(affected part number 45009K3Pro.S)

This Field Safety Notice (FSN) contains important customer information for patient safety and for the safe use of *exoplan*, our software for implant planning and surgical guide design.

Internal exocad Reference: #322799

exocad product, commercial name: *exoplan*

Figure 1: Sketch comparing the distance situation between sleeve, implant and drill for the wrongly entered drill (left) and the correct drill (right).

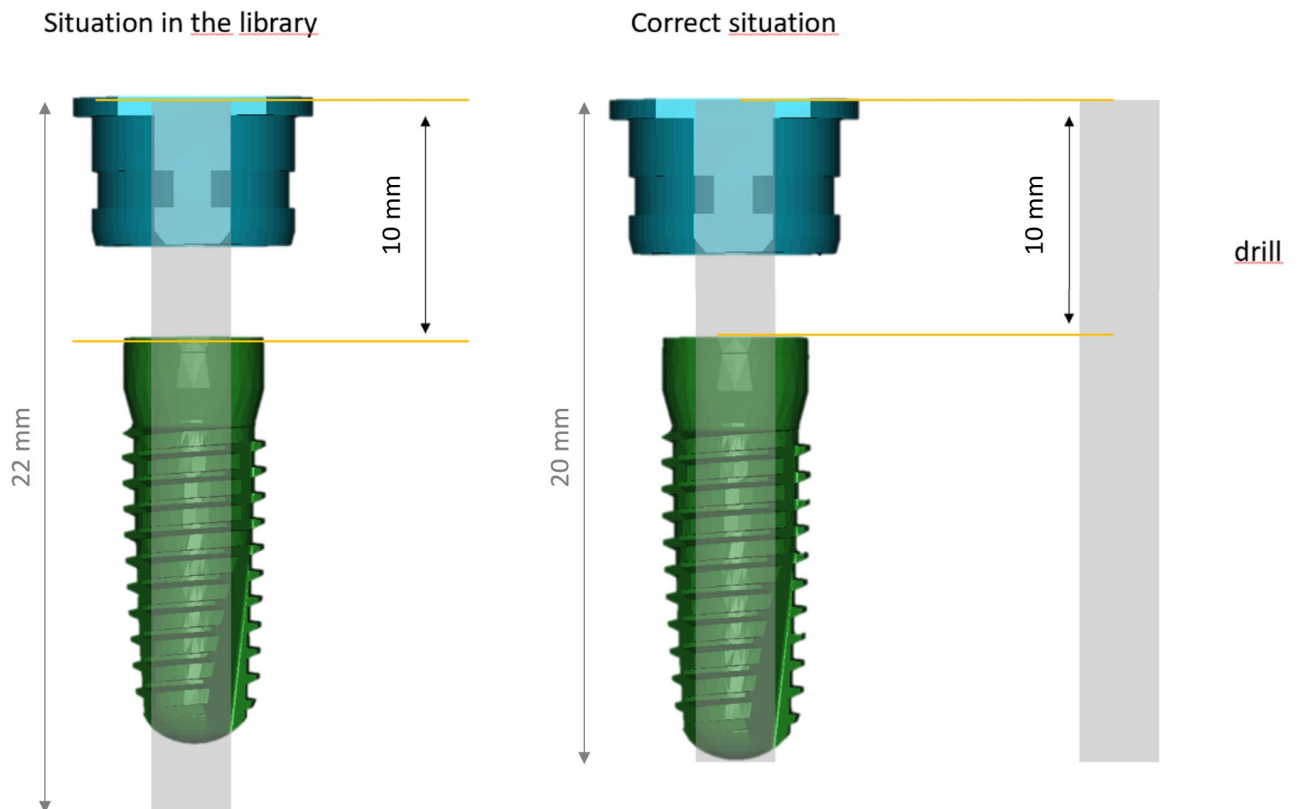
The issue is an incorrect specification in the Argon_Rapid_Surgery_sleeve libraries, suggesting the use of a surgical drill that results in a 2 mm deeper drill hole than expected due to a dimensional error in the affected libraries.

During an update of data used in a library shipped with *exoplan* or made available on the download portal of exocad, it was found that the use of a specific combination of an implant, sleeve and surgical drill can result in a hole being drilled 2 mm deeper than expected.

The identified issue in the Argon Sleeve Library, where incorrect drill length information is reported, poses significant risks to patient health during dental implant surgeries. Specifically, the software indicates a drill length that is 2 mm longer than necessary. The software provides a default safety margin of 1.5 mm, which as a result of the incorrect drill length information, is insufficient, as it is also shifted by 2 mm. This error can lead to over drilling beyond the intended surgical boundary.

- 4) New library version of Argon_Rapid_Surgery_sleeve have been released (<SignatureDate>2024-05-07T14:47:36.6611068Z</SignatureDate>). Users can now download and install the new libraries.

- 1) Do not use the affected libraries - see section “Affected libraries” above.
- 2) Download the new libraries at <https://exocad.com/integration/exoplan-library-integration> or use exocad *Library Manager* from within *exoplan*.

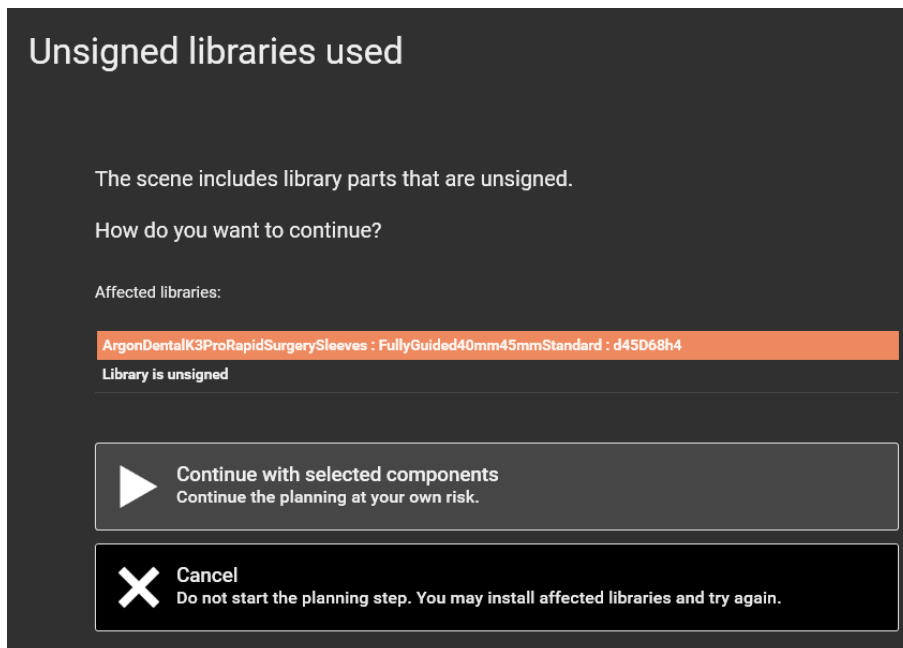
- 2) As a result of the blacklisting, if the user tries to select a component in the affected library, the user receives a message indicating that the selected sleeve library is marked as “unsigned” and should no longer be used. This message appears when the user selects the blacklisted library, as well as before the implant planning and surgical guide output data is generated. Users notified by this warning should click “cancel” and not “continue”. If users click continue, they continue at their own risk.

Figure 3: Unsigned library message of a blacklisted Argon® library to the user when loading a scene file that already contains the affected library.

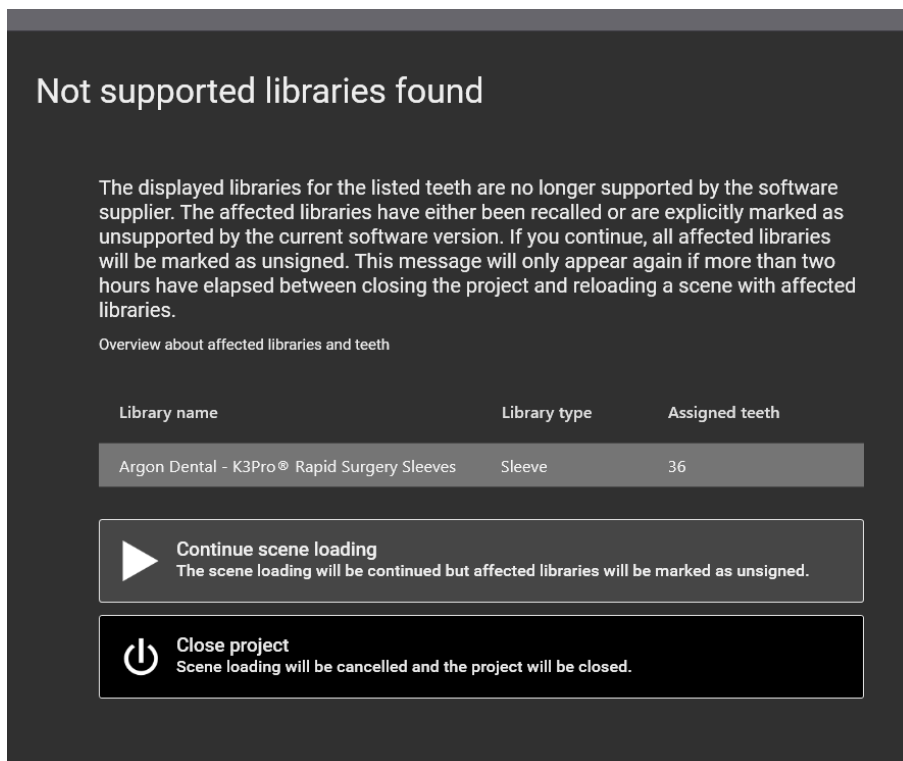
- 3) If an implant planning “scene file” (file containing all the information about a planning or design scene, e.g., workflow state, scene objects) is loaded into *exoplan* that previously used the blacklisted sleeve library in the implant placement planning, a warning message appears to inform the user about the unsigned library (see figure 3).
